Addendum 02

PROJECT: Fort Loramie Local Schools Athletic Complex Building & Associated Improvements
600 East Park Street
Fort Loramie, Ohio 45845

PROJECT #: 25041.00

SECOND FLOOR LIGHTING PLAN

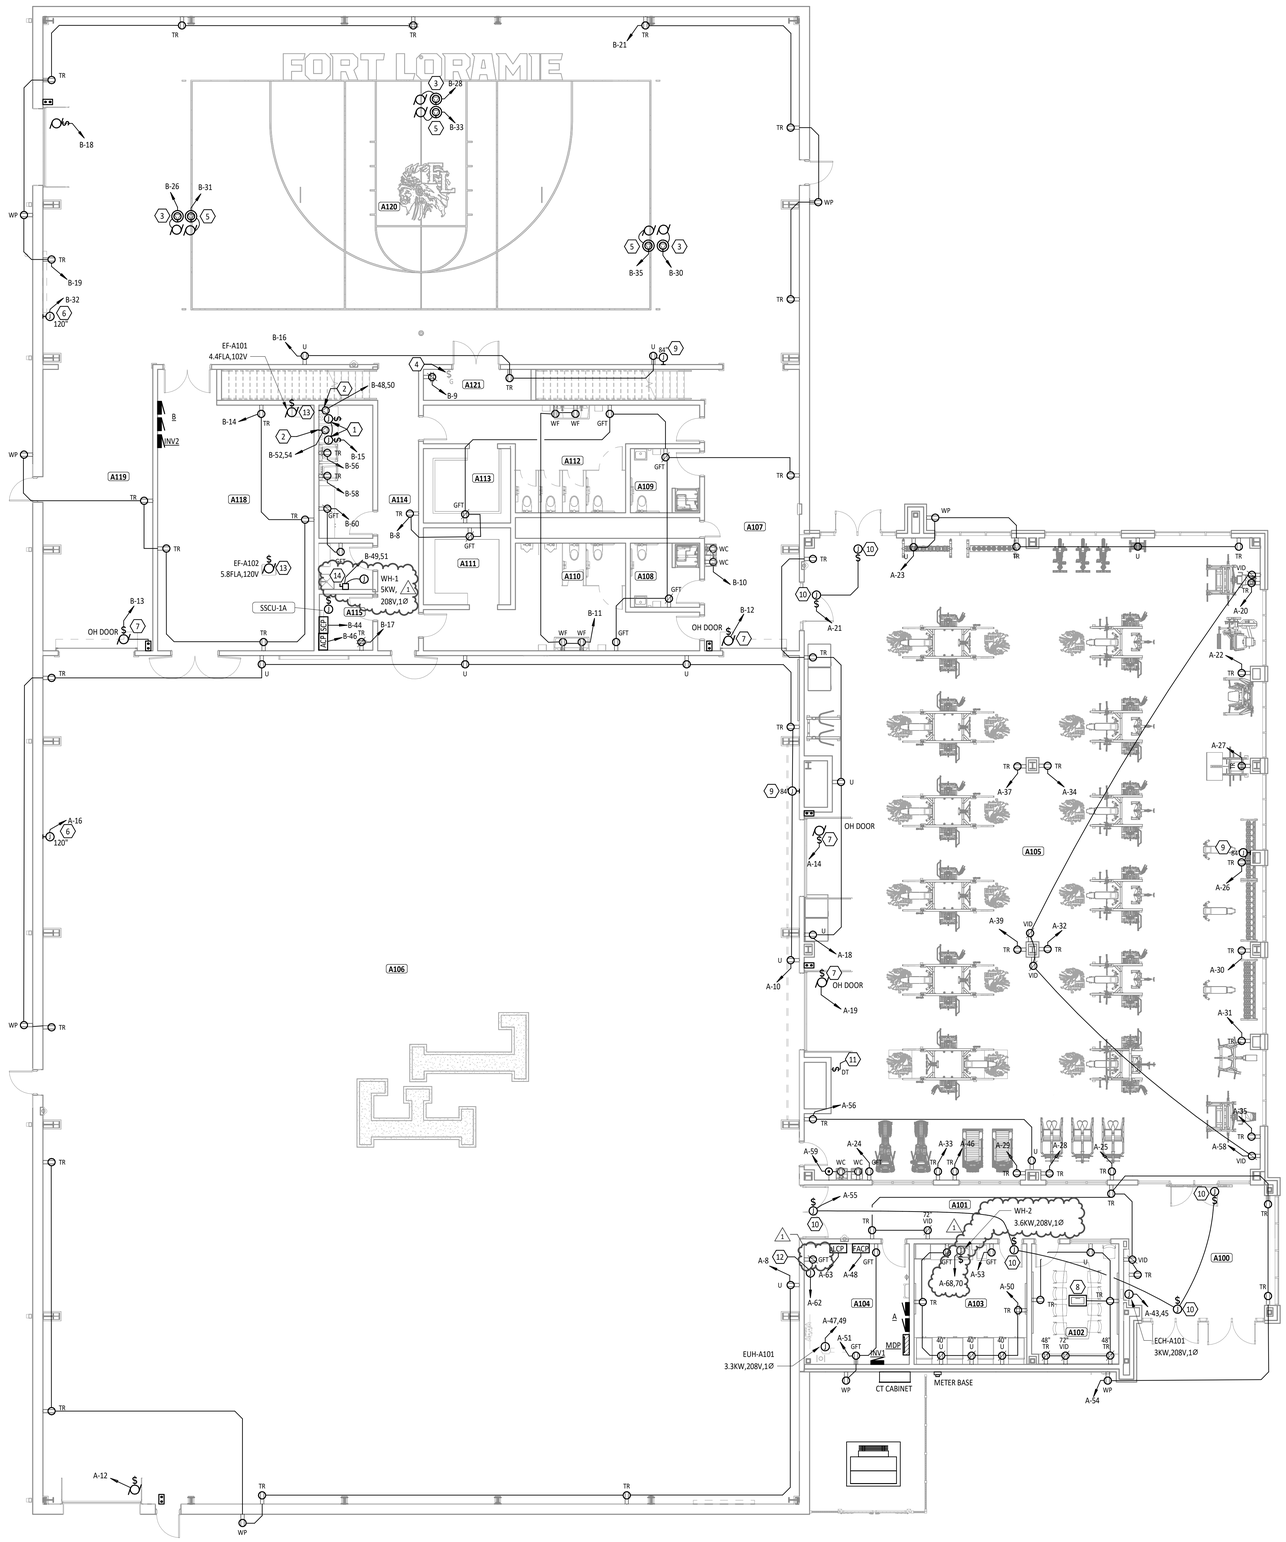
25.) E4.2 Second Floor Lighting Plan – Updated lighting control devices to be 3-way.
26.) E5.1 First Floor Power Plan – Add receptacle in A104 for water softener, add WH-2 connection in A103 and revision to WH-1 information in A116.
27.) E7.1 Luminaire Schedule – Add 'TA' fixture to schedule.
28.) E8.1 Electrical One-Line Diagram and Panel Schedules – Revisions to panel schedules.

1 FP1.1 **FIRE PROTECTION PLAN**
1/8" = 1'-0"

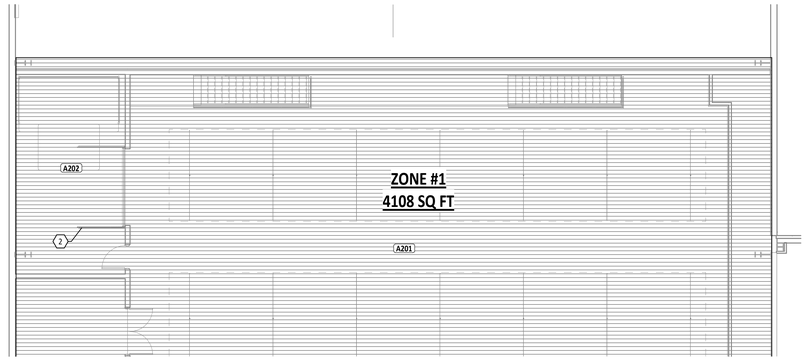
21.) P6.1 Sanitary Isometric – Move vent through roof and water cooler vent pipe.
22.) FP1.1 Fire Protection Plan –Add Sprinkler Mains and keynotes to clarify routing of the sprinkler piping.

SITE LAYOUT AND MATERIALS PLAN

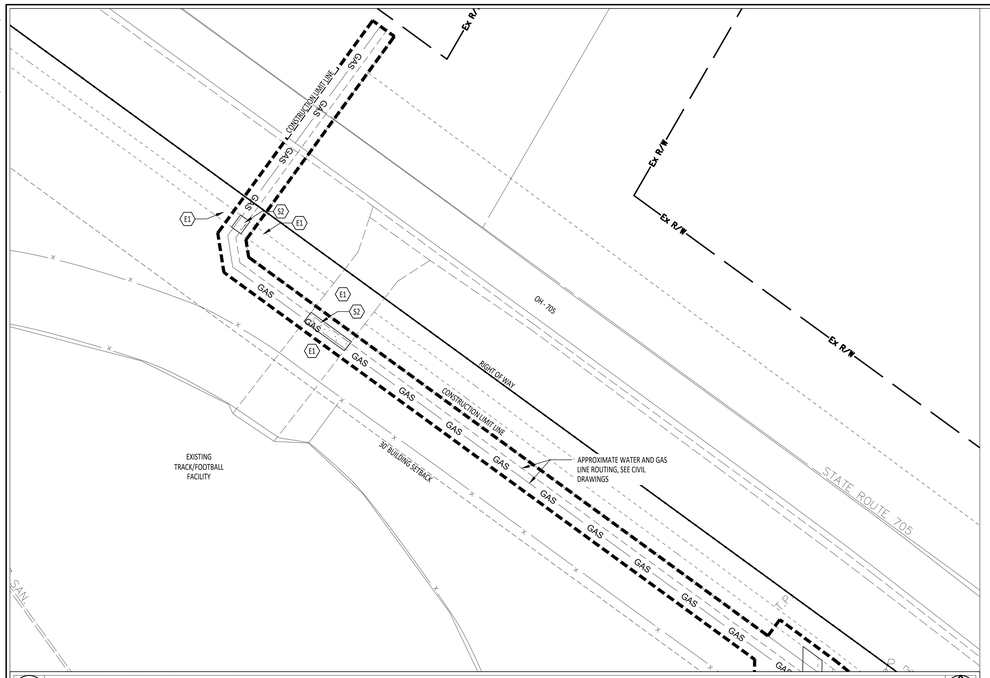
4.) L1.1 – Revised walk layout along North and Northeast side of proposed building
    a. New walk to wrap around the north side.
    b. Remove concrete stairs and handrails from the scope.

3 L3.1 PLANTING PLAN
1" = 10'-0"

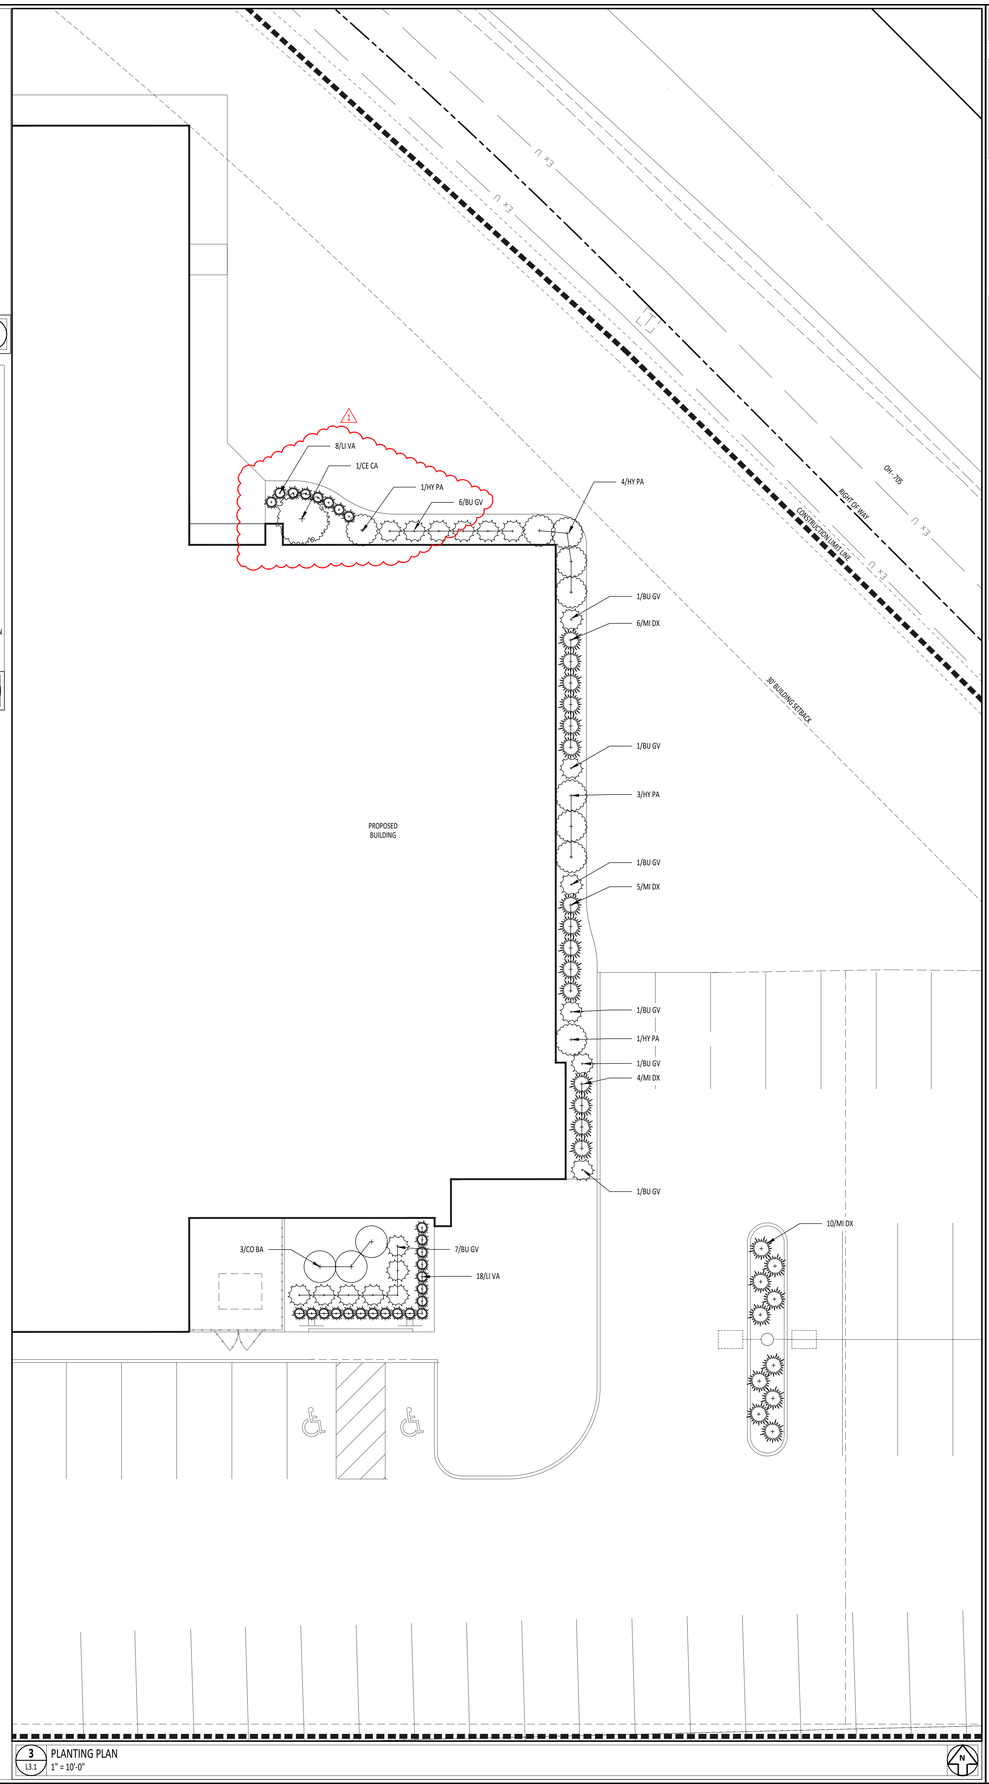
5.) L2.1 – Removed concrete stair detail
6.) L3.1 – Revised plant bed layout
    a. Reduced (2) Variegated Lily Turf
    b. Added (1) Green Velvet Boxwood

SITE PLUMBING PLAN

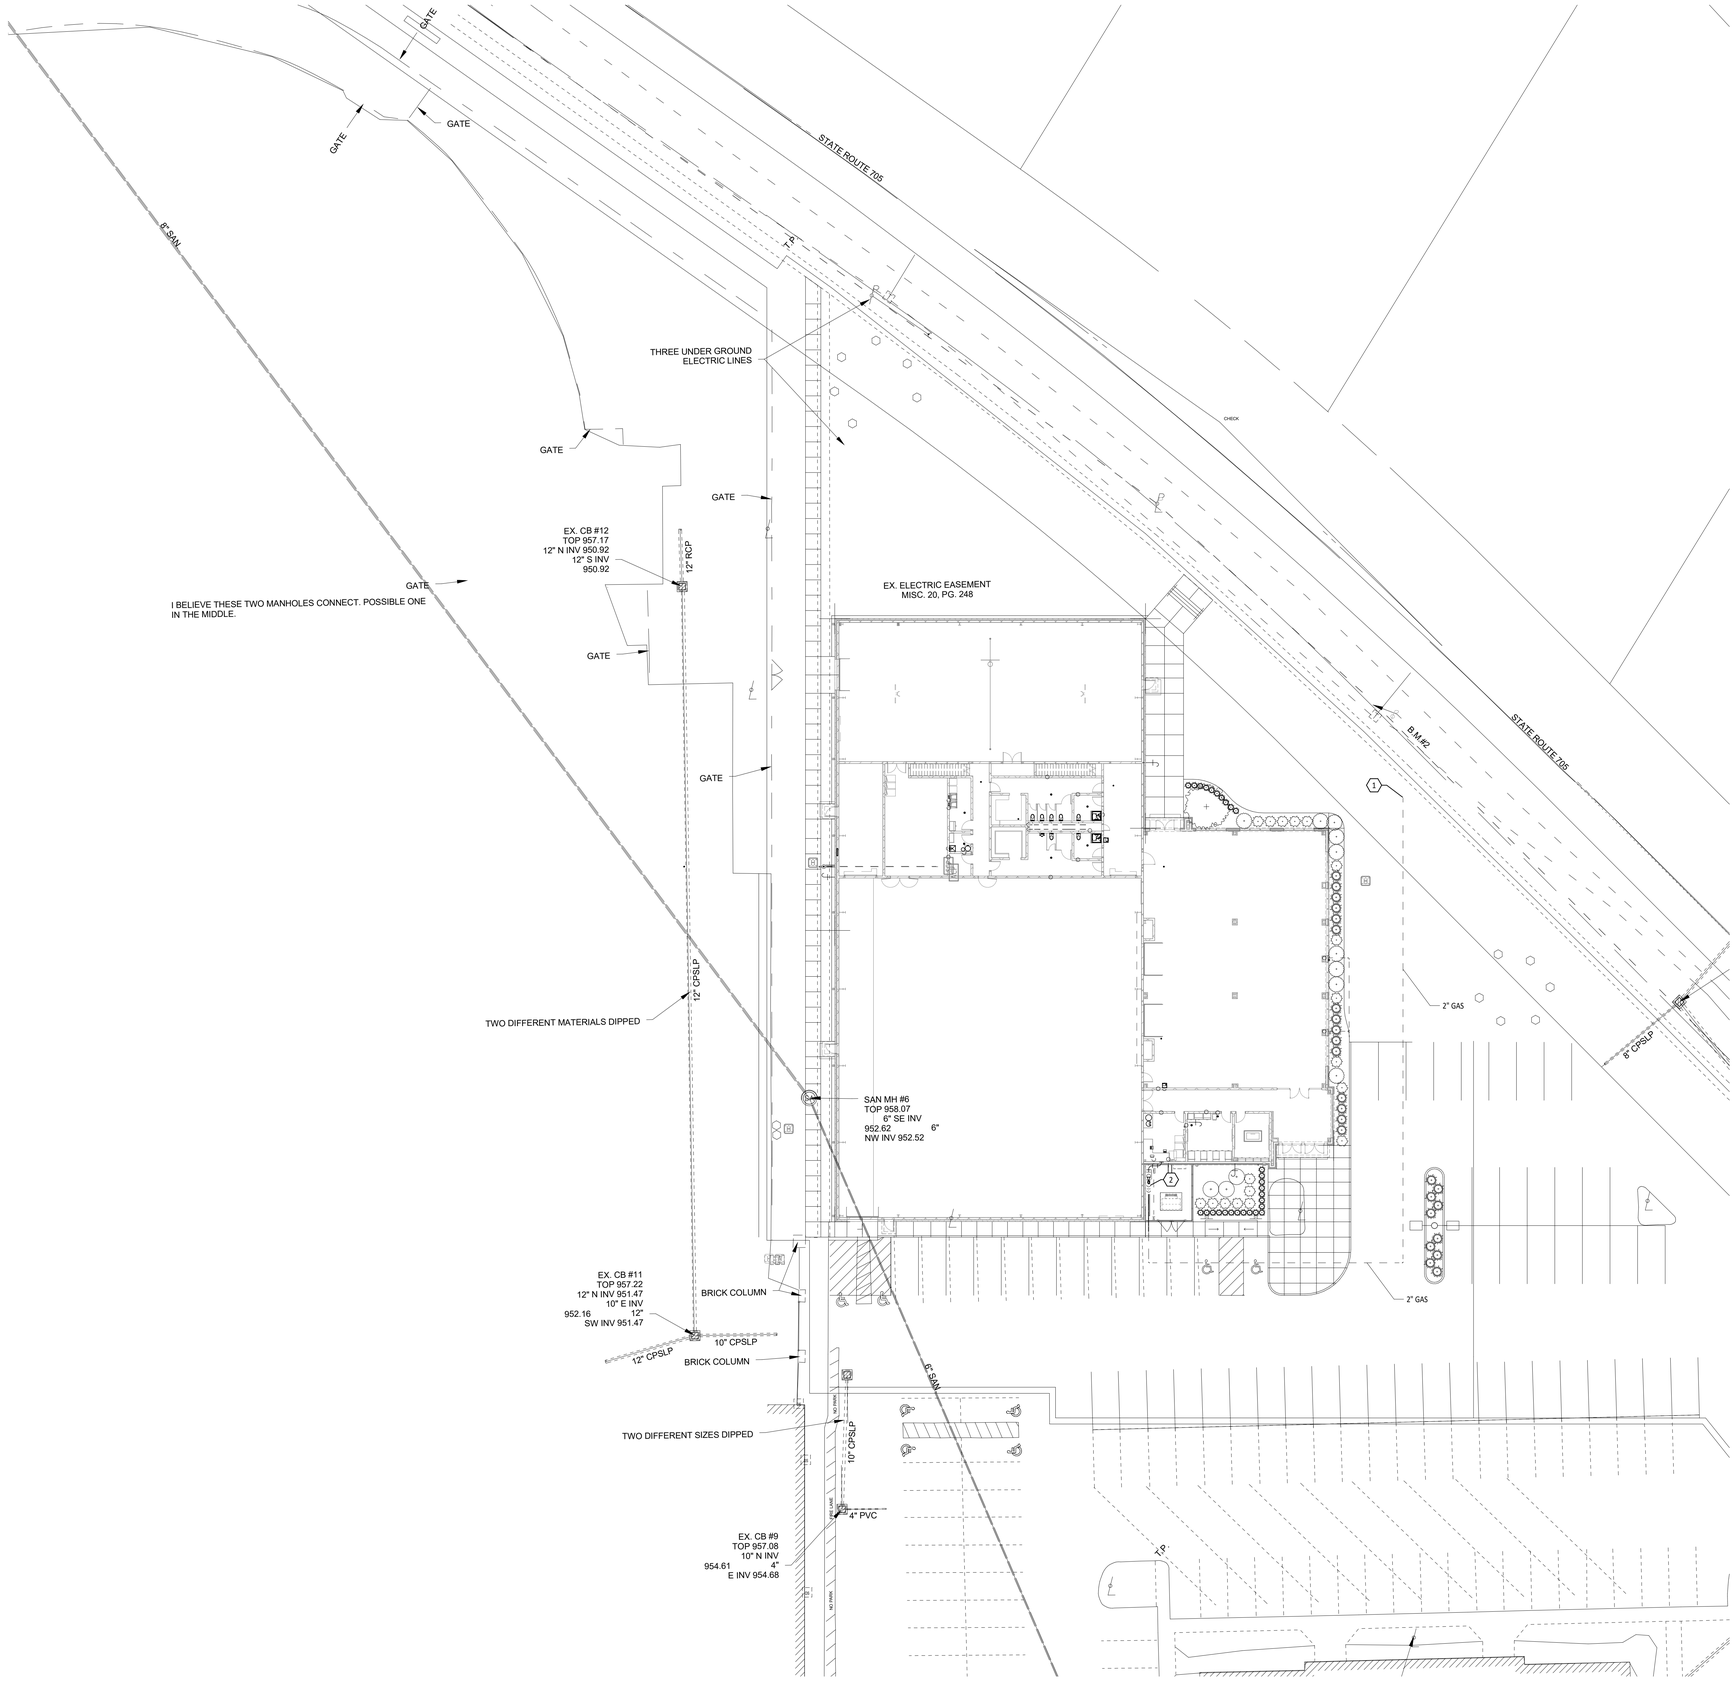
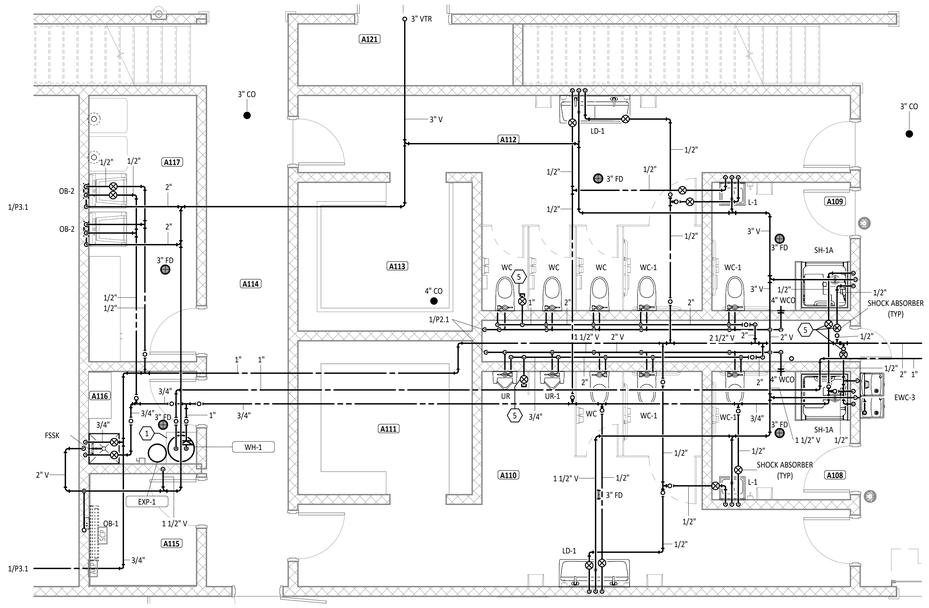
19.) P1.2 Site Plumbing Plan – New sheet showing site gas piping.
20.) P4.1 Enlarged Plumbing Plans – Move vent through roof to avoid ductwork. Reroute water cooler water and vent piping to minimize pipe in the corridor.
